Flintshire Local Development Plan 2015-2030

Statement of Common Ground

**STR3B Warren Hall – Aerodrome safeguarding and
agreed site development extents**

July 2021

Warren Hall Spot Heights

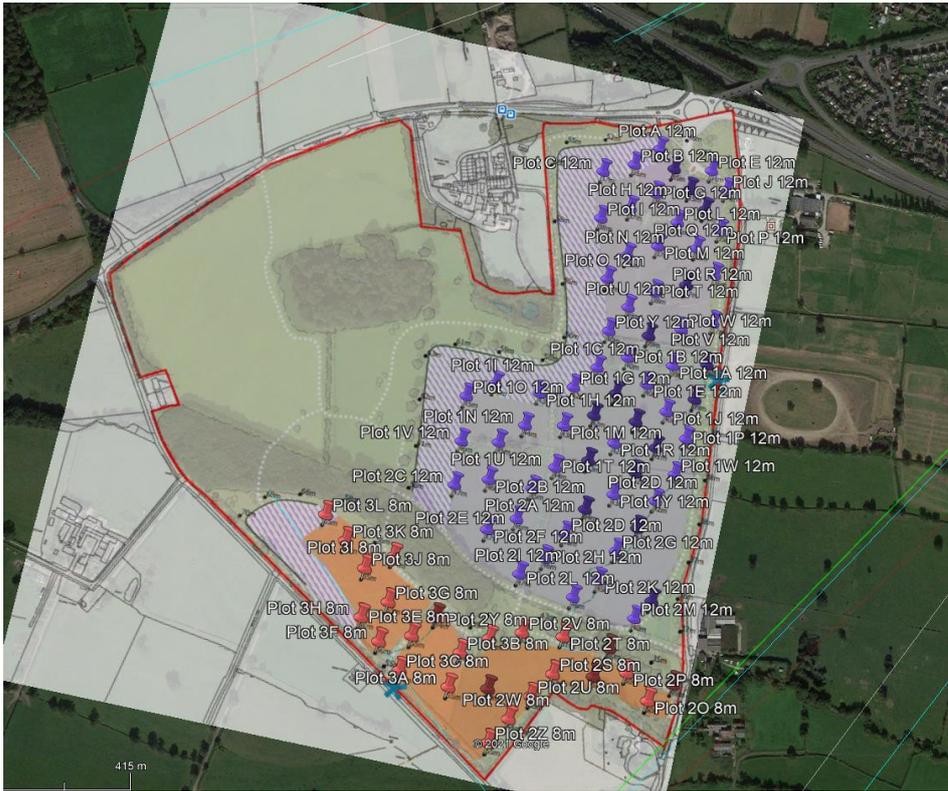
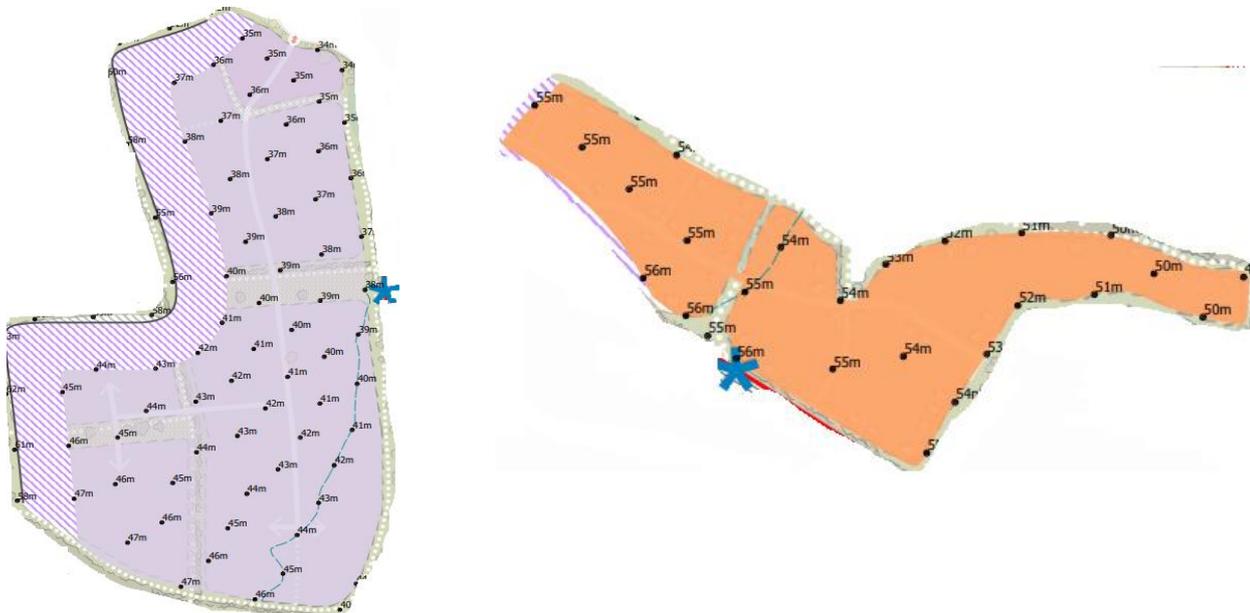
Airbus has assessed all spot heights provided and there is no infringement to the approach and take off surfaces of runway 04. There is still an infringement to the inner horizontal which **could** be acceptable subject to an approved Safety Assessment.

1. **Safety Assessment** - The inner horizontal surface **may** be infringed subject to a suitable safety assessment being carried out. This suitable safety assessment should be conducted by a CAA accredited Approved Procedure Design Organisation (APDO) consultant and must consider at the very least:
 - a. The height of the structure against the inner horizontal surface penetration;
 - b. The effects to the operational safety of the aircraft within the airspace;
 - c. The detrimental effects to landing, departing and positioning of aircraft, suggesting appropriate mitigations; and

5.2 Subject to plateau formation (based on the spot height assessment set out in Appendix 1), 20.4ha of land north of Warren Dingle is capable of accommodating employment development and commercial hub development at a maximum height of 12m, and 6.7ha of land south of Warren Dingle is capable of accommodating residential development at a maximum height of 8m. This can be achieved without infringing the approach and take off slope for Runway 04 based on current regulations. While the development would infringe the inner horizontal surface, this would probably be considered an acceptable infringement if a verified safety assessment supporting this premise is produced at the detailed design stage, following adoption of the LDP (as it has not being possible to carry out a safety assessment in the absence of a detailed layout and building design).
